## DIXON MEADOWS JSP14-46 with Rezoning 18.709

Public hearing at the request of Pulte Homes for Planning Commission's Recommendation to City Council for a Planned Rezoning Overlay associated with a Zoning Map amendment, from RA (Residential Acreage) to RT (Two-Family Residential). The subject property is approximately 22.36-acre and is located in Section 10 on the east side of Dixon Road, north of Twelve Mile Road. The applicant is proposing a development of a 90-unit single-family residential detached site condominium.

Review based on 3<sup>rd</sup> Revised Concept Site Plan on December 14, 2015

**CONCEPT PLAN**

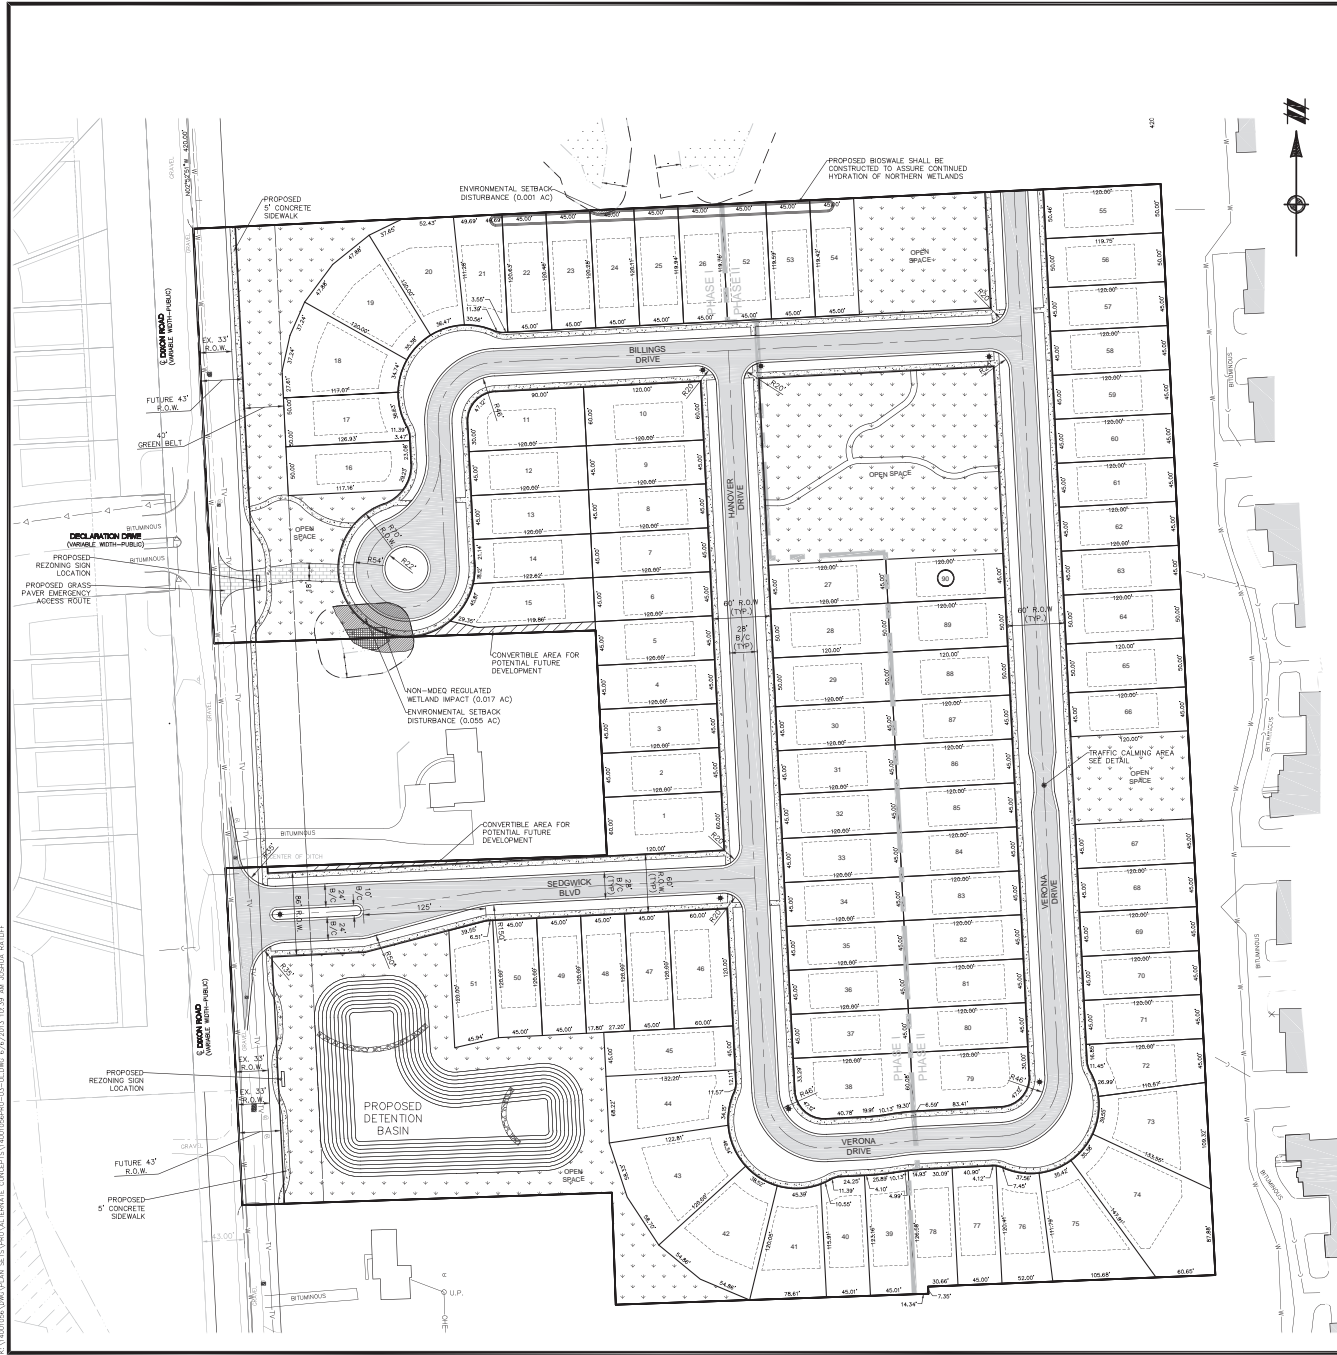
ITEM	Revisions per Plans dated September 14, 2015 (reviewed by staff and consultants, but not presented to the Planning Commission)	Revisions per plans dated December 14, 2015
Rezoning Request		Requested rezoning from RA (Residential Acreage) to RT (Two Family Residential) to more closely match the proposed density. Previous request had been to rezone from RA to RM-1 (Low Density, Low Rise Multiple Family Residential).
Number of lots/ Density	Reduced the number of lots from 95 to 92. 4.4 units/acre	Reduced the number of lots from 92 to 90. 4.2 units/acre
Site Layout		Staff recommended revisions to the design to break the long lineal pattern along Verona Drive. The plans were revised to show a pavement narrowing along the east roadway for traffic calming. In addition, two (2) home sites were removed (previous units 67 & 68) and a pocket park provided for the neighborhood. The area selected will preserve several existing trees along the east side of the new open space, and a play structure and will be added in the front area of the park. The pavement narrowing will provide a focal point to the pocket park. and support the reduction of vehicular speed in the community. The pocket park will break-up the linear feel of the roadway block. In addition, Pulte Homes is proposing to off-set front setbacks along the eastern roadway, to provide varying home setbacks, ranging from 2-3 feet.

Open Space	Relocated and increased the Open Space/Tree Preservation by approximately 0.75 acres for a total of approximately 1.54 acres on site. The modifications will help protect higher-quality woodland areas within Open Space.	Applicant has now proposed additional open space on the east side of the site between lots 66 and 67. The current plan proposes open space/preservation areas in four locations along the development totaling approximately 3.35 acres (15% of total acreage of 22.36 acres). Further detail is provided on sheet 05.

Additional preservation is proposed to create open space along Verona drive. The applicant is proposing to reduce lot sizes to plant more replacement trees behind lots 42, 43, 18 and 19 as illustrated in sheet L-1. 1.
<b>Usable Open Space</b>		<p>A rustic trail is proposed in the large central open space area, to provide for active walking area within the interior woodland park.</p> <p>Additional preservation is proposed to create open space along Verona Drive. The applicant is proposing to reduce lot sizes to plant more replacement trees behind lots 42, 43, 18 and 19 as illustrated in sheet L-1. 1. The tree calculations were modified to correspond to the current city consultant methodology of counting the percent removal.</p>
<b>Tree Removal</b>	<p>A total of 96 fewer regulated trees are now proposed to be removed for the development (89 percent of the site's regulated trees were proposed to be removed previously, 85 percent are proposed to be removed at this time).</p>	<p>A total of 620 trees out of 742 regulated trees are proposed to be removed. (85 percent of the site's regulated trees were proposed to be removed previously, 83 percent are proposed to be removed at this time).</p> <p>The tree calculations were modified to correspond to the current city consultant methodology of counting the percent removal.</p>

<b>Site Access</b>	<p>Removed the north entrance and made the main south entrance a long Boulevard, removing the stub streets to the remainder property in the center of the site.</p> <p>Temporary Secondary Access to Dixon Road is not shown but is being requested by the Fire Review letter to be installed and in place until the property to the north is developed.</p>	<p>The entrance boulevard roadway and associated right-of-way was reduced in length, and an additional lot was added along the entrance drive.</p> <p>An emergency grass paver access drive is proposed to Dixon Drive from the proposed cul-de-sac at the northwest corner of the site. The area surrounding the access drive to proposed to be developed as Open Space.</p>
<b>Storm Basin</b>	<p>Relocated and consolidated the detention basin to the southwest part of the site.</p>	
<b>Additional Clarification</b>	<p>Provided an exhibit that shows the limits of arsenic removal, and areas of quality woodlands, as requested (Sheet L-8)</p>

The Concept Plan has been modified from the plan that was reviewed for Pre-Application submittal, for the Planning Commission's first public hearing on the matter, and for the Planning Commission's second hearing as noted above. Open space near the center of the site, has been relocated to the northeast part of the site in order to preserve quality trees. Additional open space is provided on the east by eliminating two lots in the middle of the east side, along Verona Drive, and around the proposed emergency access in the northwest corner along Dixon Road. Total usable open space has now increased from about 0.77 acre (3.5 percent of the total site area) to 3.35 acres (15 percent of the total site area).

Staff agrees that the changes to the most recent plan are a considerable improvement from the last plan reviewed. The current site plan provide better pedestrian connectivity within the development, preservation of additional quality woodlands, and visual breaks from the linear form of development.

Staff suggested the applicant consider alternative designs to break up the long straight rows of homes that are proposed (especially the 22 homes that were previously shown along the east property line). In response, the applicant eliminated two lots to create additional open space, preservation of quality woodlands (outside of arsenic-affected areas) and proposed a traffic calming design along Verona drive. The applicant expanded further on the design concept in his cover letter. At the public hearing, the Planning Commission may wish to discuss with the applicant
